RE: AMENDED REQUEST 200 MW BLAZING STAR WIND FARM 2  
WIND ENERGY PROJECT SITE PERMIT  
DOCKET NO. IP-6985/WS-17-700

The permit amendment is requested to address (1) a new, expanded project boundary; and, (2) an updated turbine layout that incorporates Vestas V-110 and V-120 turbine generator models.

## **Attachment A – Project Boundary Comparison**

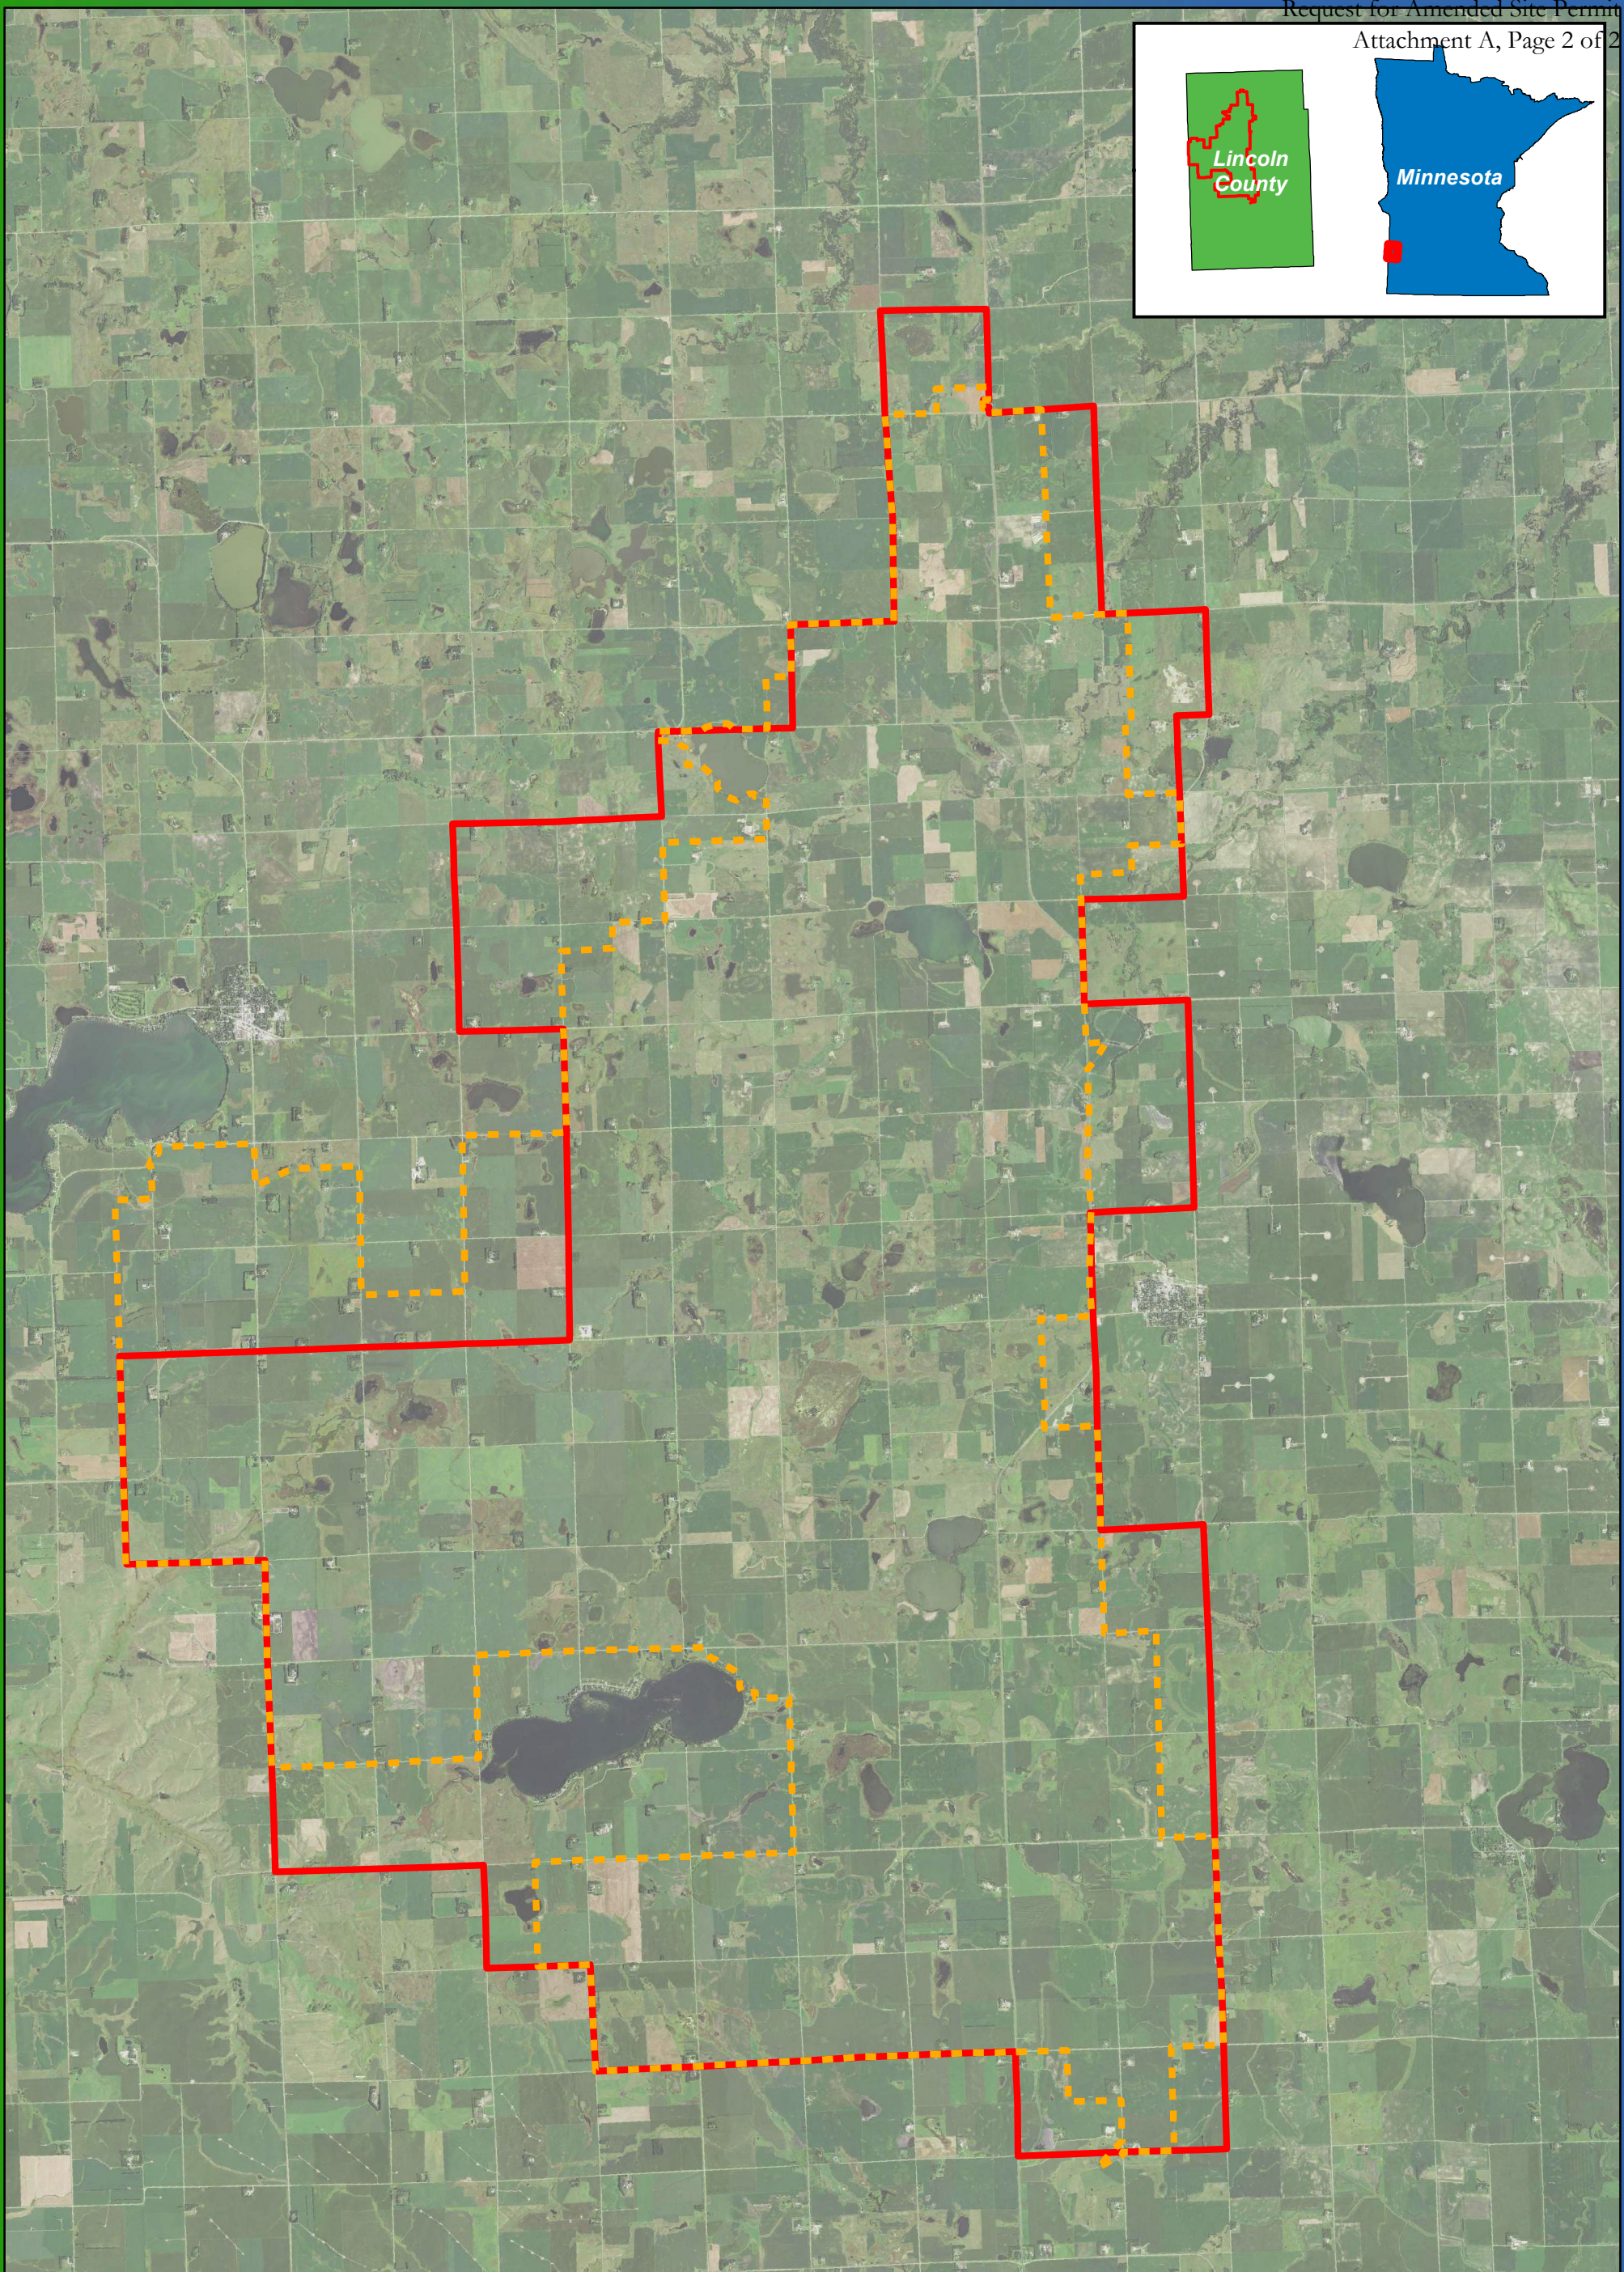
The project boundary is amended as shown in Attachment A to this application. The change is the result of additional landowner interest participation in the Project and to reduce the overlap with the Blazing Star 1 Project boundary.

The Company confirms the updated facility layout complies with this requirement. The Figure in Attachment D illustrates the required wind access buffer. The project boundary has changed to incorporate additional easements. A project boundary comparison is provided in Attachment A.

## **Attachment B – 2019 Layout**

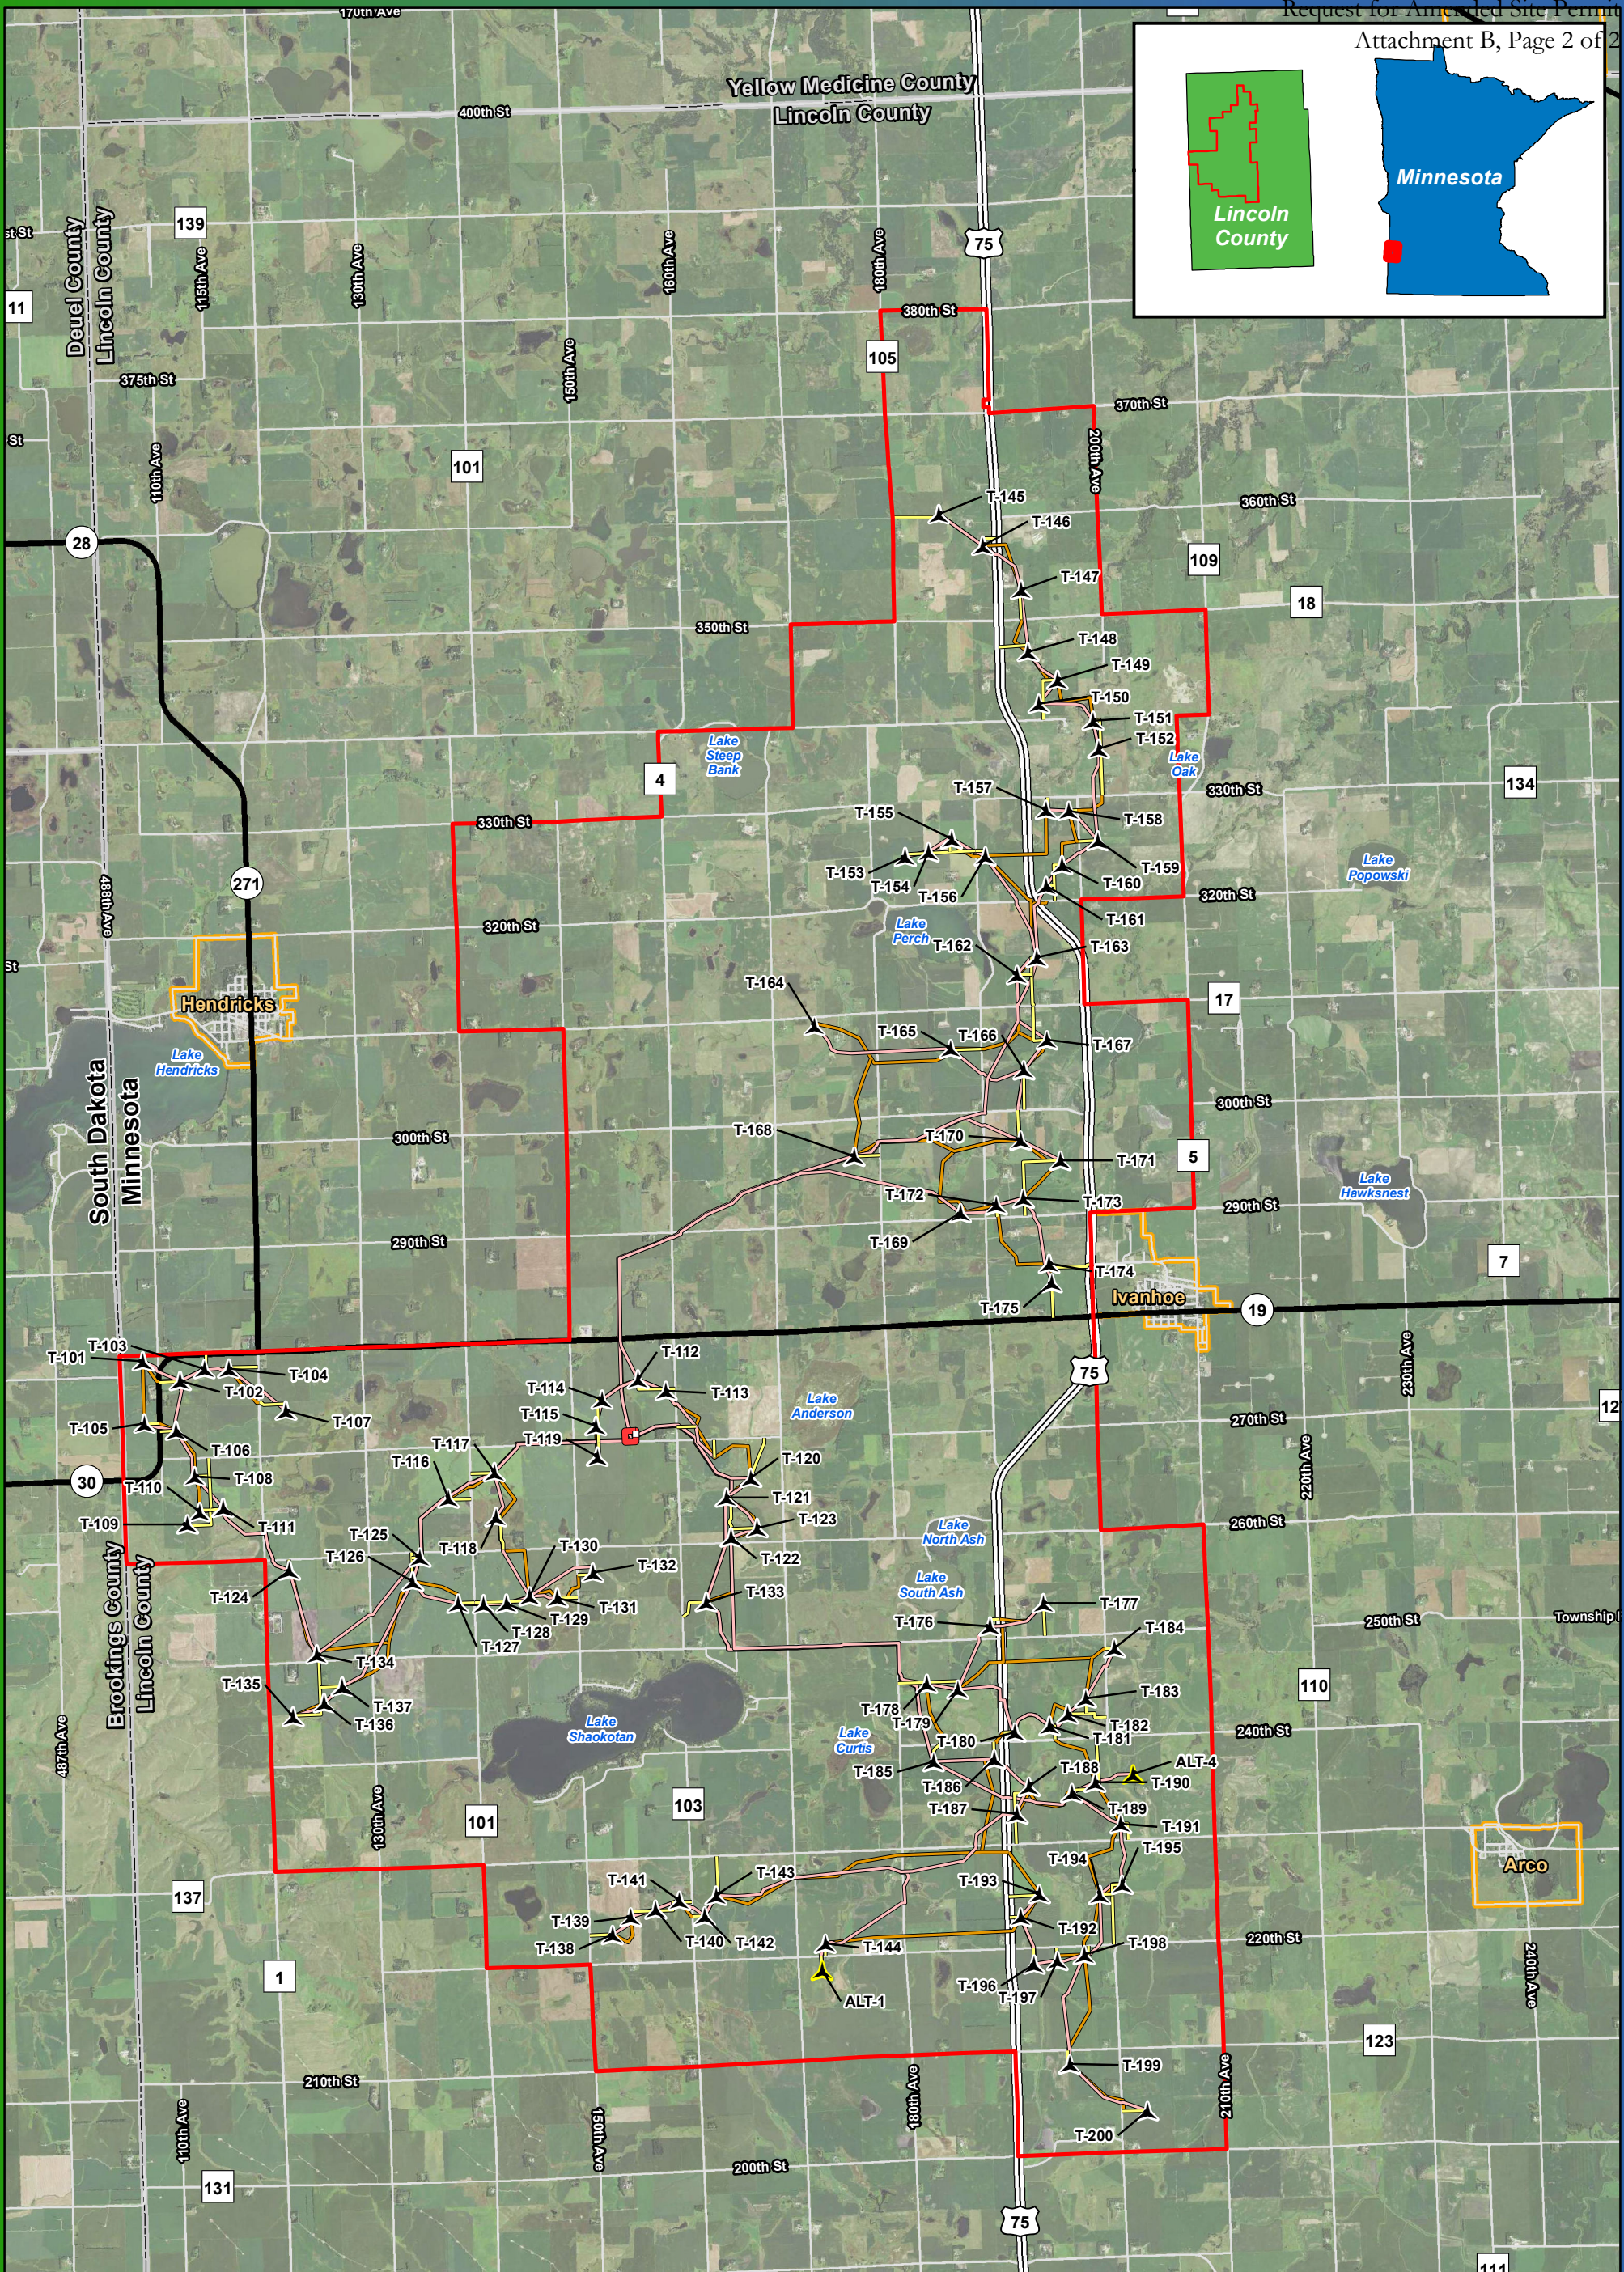
The Site Permit currently references official site maps attached to the permit. These maps show wind turbine and associated facility layouts for Gamesa G126, Acciona 3.0-132, GE 2.5-116, and Vestas V-110 turbines. We provide as Attachment B to this request, a map showing the final project boundary and turbine layout with Vestas V-110 and V-120 turbines. The Company requests approval to amend the permit with the site maps with those provided in Attachment B.

We provide as Attachment B, an amended map of the project facilities, including collector and feeder lines. The Site Permit provides general specifications for collector and feeder line installation. Similar to many other wind farm construction projects, design of this project's electrical collection system has evolved, and continues to be refined, with project development and completion of environmental studies. Per the updates to Section 8 of the Site Permit Application above, impacts to human health and the environment are being minimized to the extent practicable and will be similar to or less than impacts anticipated from the original permitted designs. Projected impacts are primarily temporary and are related to wetlands, native prairie, agriculture, soils, and other resources addressed in the site permit application. The Company will submit the engineering drawings of all collector and feeder lines in the site plan pursuant to Section 10.3 of the Site Permit.
